BT27.50-P-0002-02A	Plain bearing of input shaft changed to an anti-	
	friction bearing

## TRANSMISSION 722.60# /61# /660 /662 /664 /665 /69# ## as of 1317917 as of 7.1.99, 722.62# /63# /661 /663 /666 /669 ## as of 1324240 as of 12.1.99

P27.51-2006-05

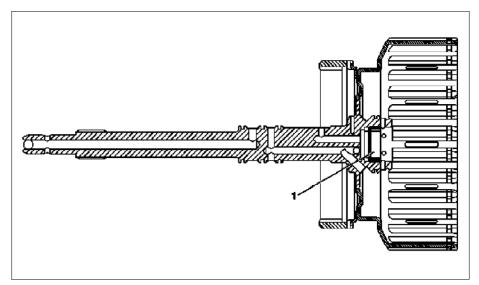
## 1 Needle bushing

The plain bearing in the input shaft was replaced by an anti-friction bearing (needle bushing).

As a result, the inside diameter of the needle bushing in the input shaft and the outside diameter of the journal at the output shaft have also changed.

When repairing a vehicle, therefore, both shafts must be replaced.
